IS3000ZL26/61 POSSIBLE MISSING HARDWARE ON CRANKSHAFT BOLT.

IS3000ZL26/61

Figure 1. Correct Assembly of Crankshaft Hardware

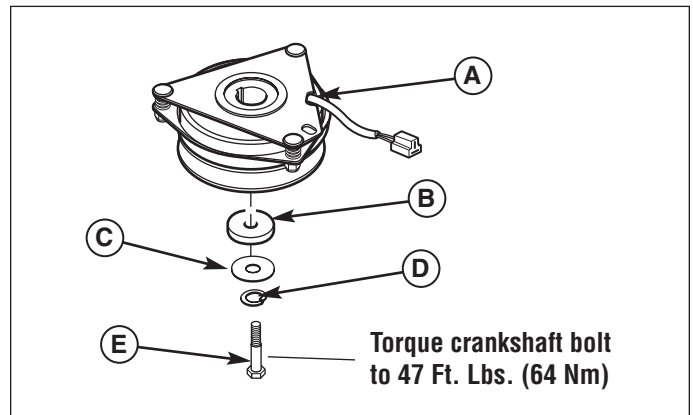
Ferris has determined that a lock washer and a flat washer may have been left off the crankshaft bolt during assembly.

1. Inspect the crankshaft bolt (E, Figure 1) for washers (C, D) as shown in illustration, if present no further action is required. If washers are not found, order and install lock and flat washer on the crankshaft bolt and torque to 47 ft/lbs.
